PLANNING TRACKING LOG

DEVELOPMENT REVIEW BOARD – SPEED MEMO

DRB CASE NO/PROJECT NO: 1005467

**April 8, 2015
DRB Comments**

SITE STUDY # 1

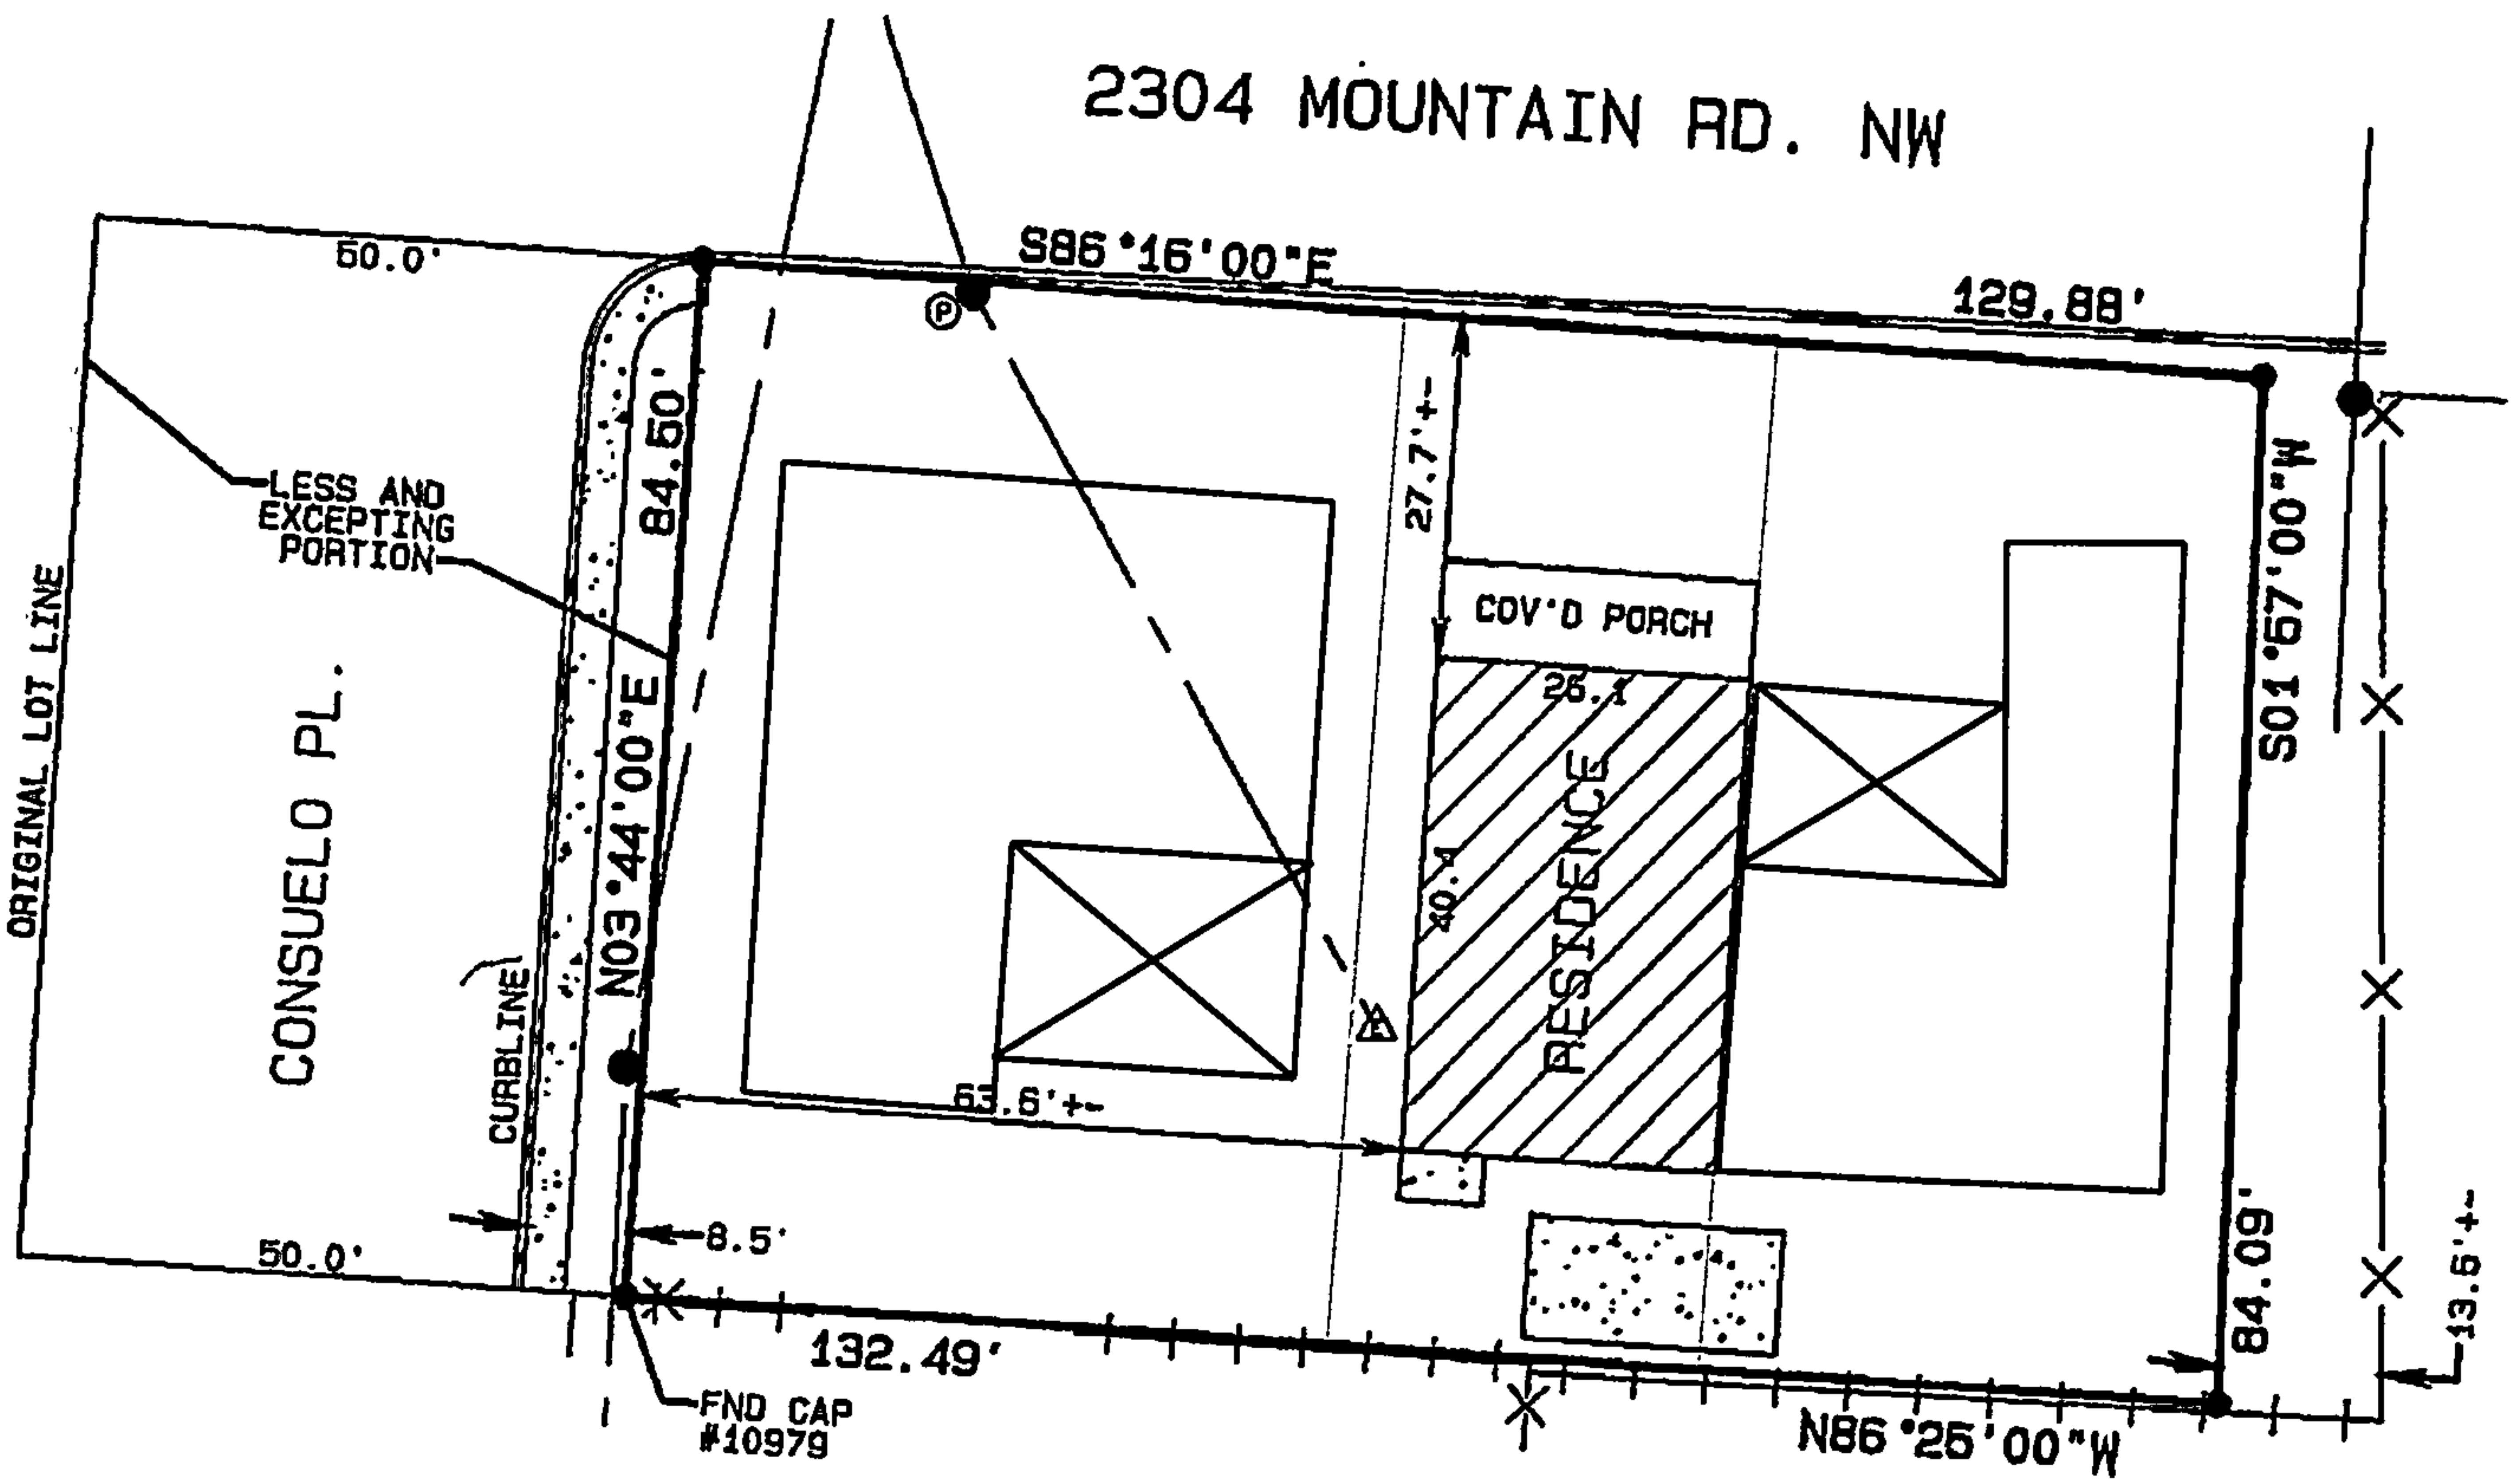
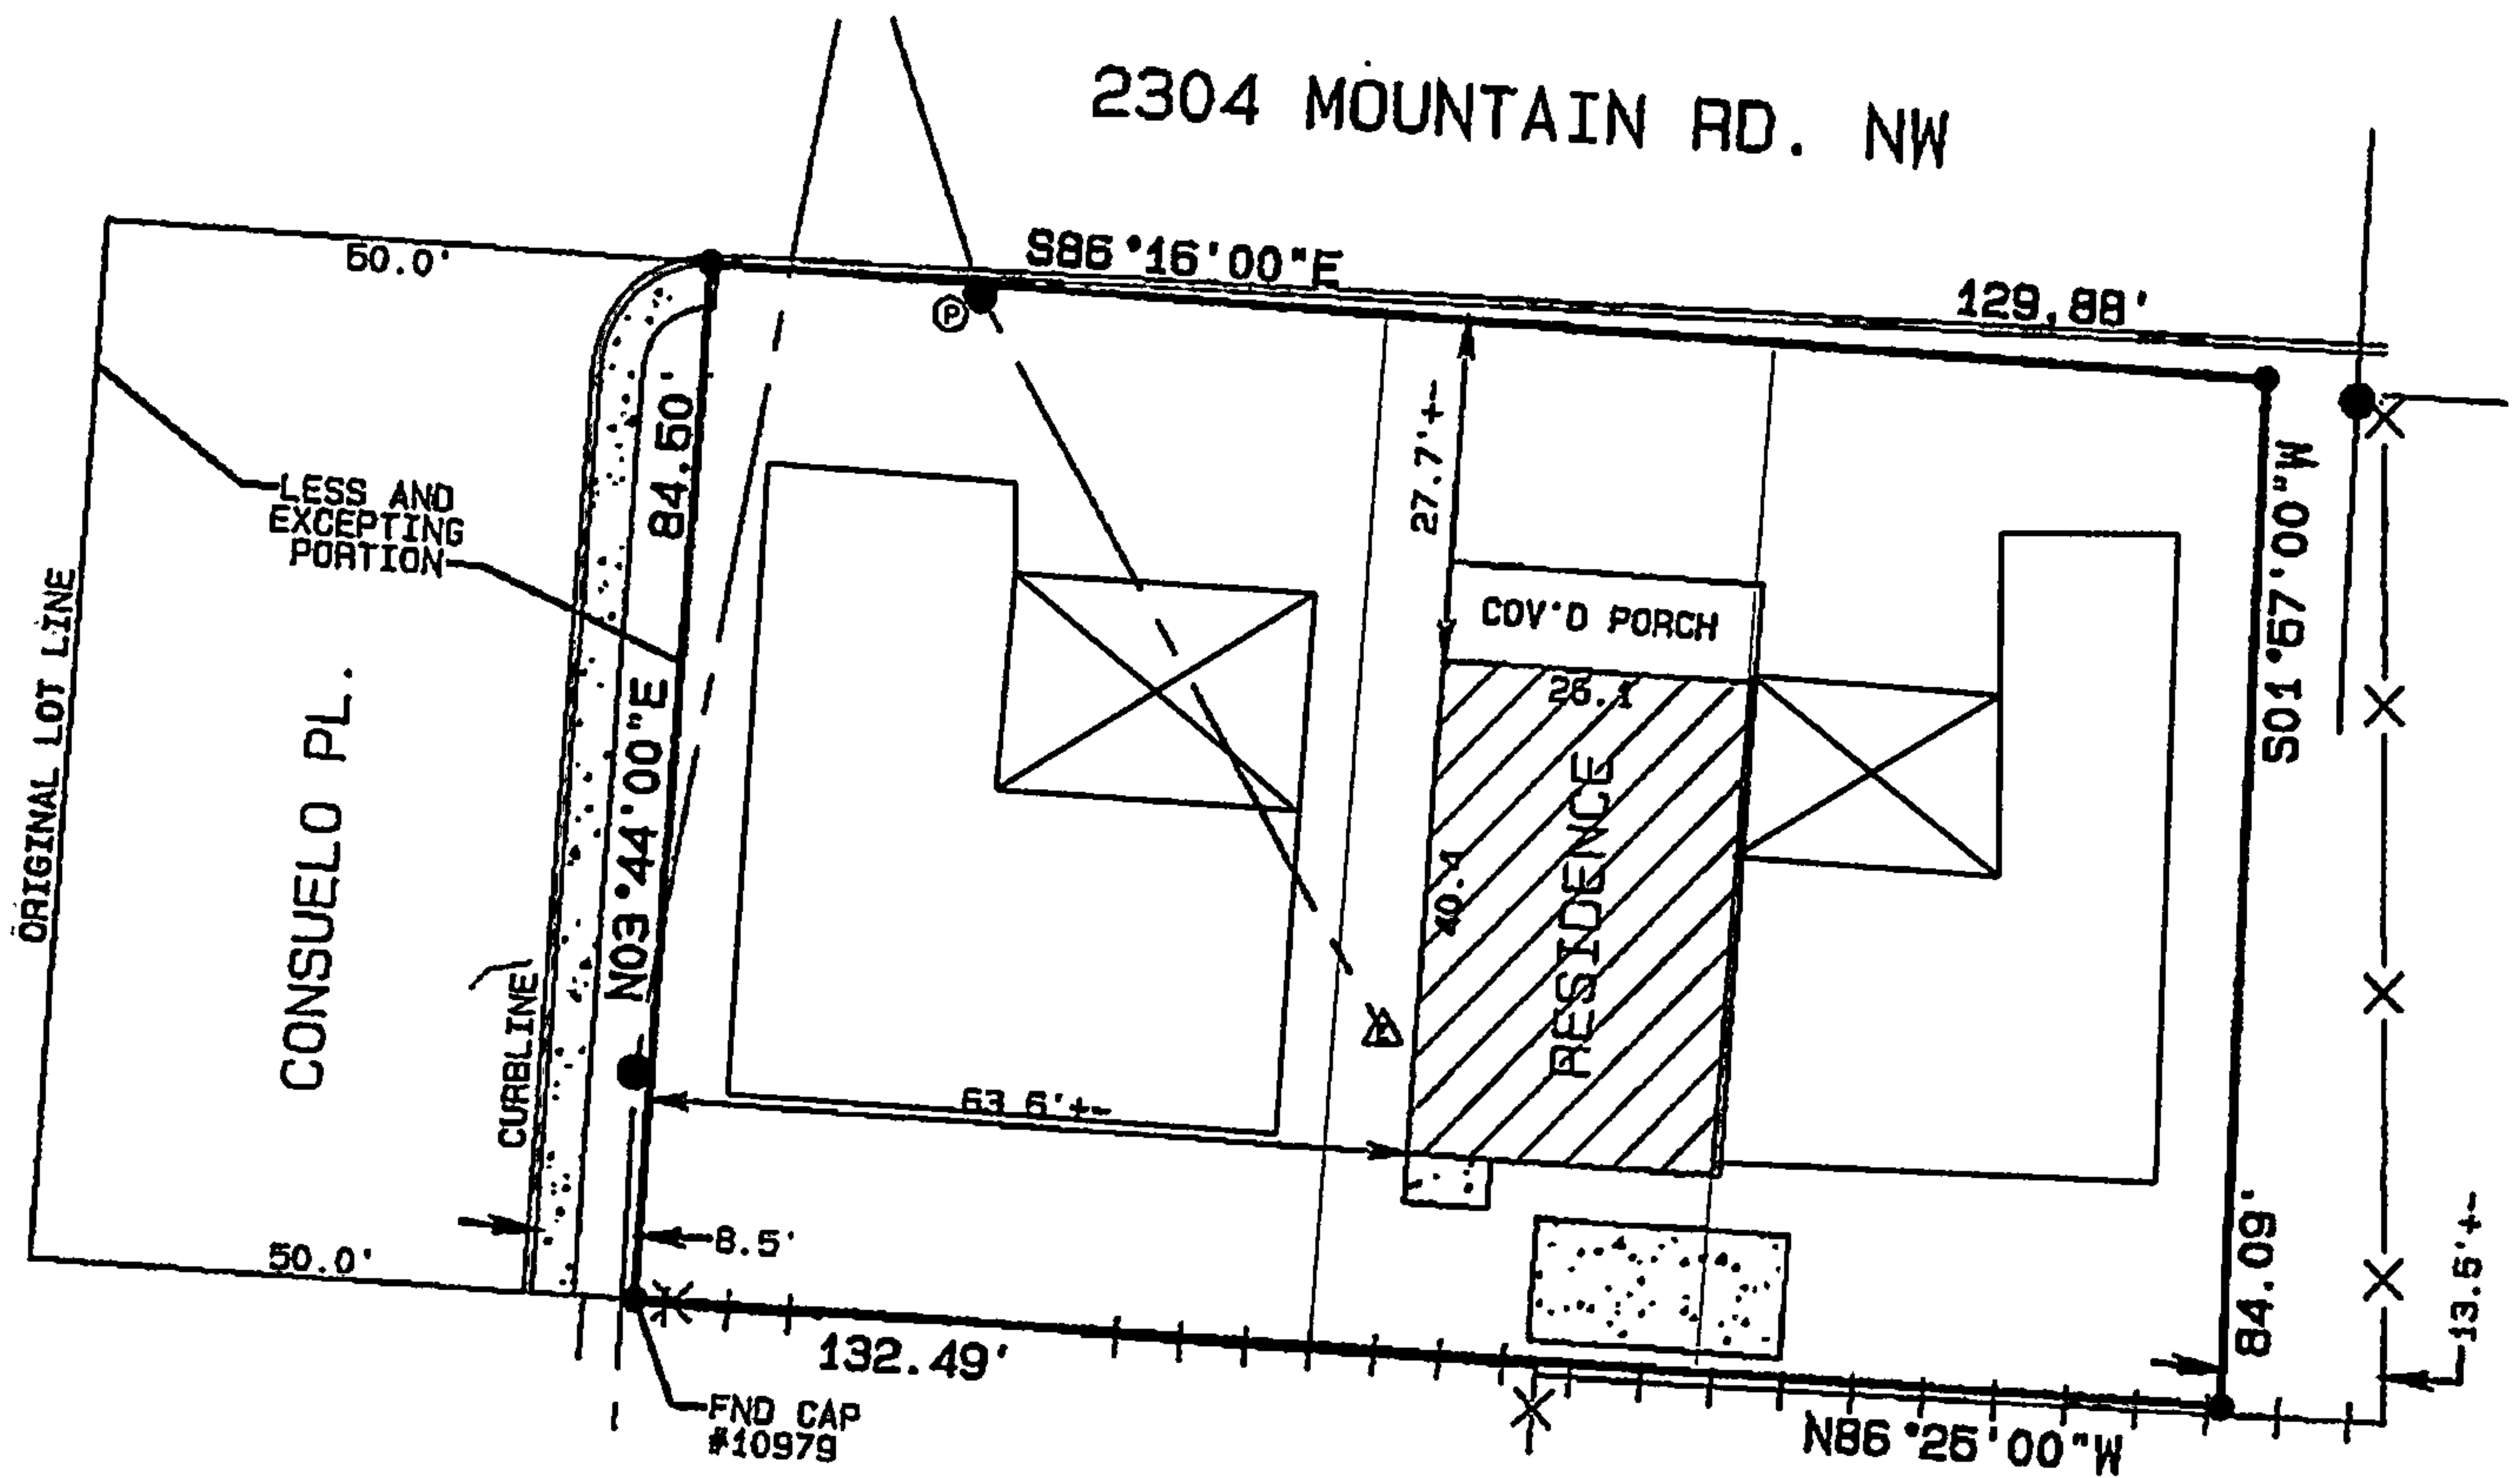
The sketch plat proposals showing three new detached houses or four new townhouses meet minimum requirements of the R-T zone; however, the original sketch with existing house/ three lots does not show square footage of lots. Any proposal involving existing structure would have to comply with all code requirements, which would include minimum R-T lot sizes, widths, and setbacks as well as building code requirements for a common wall/ townhouse.
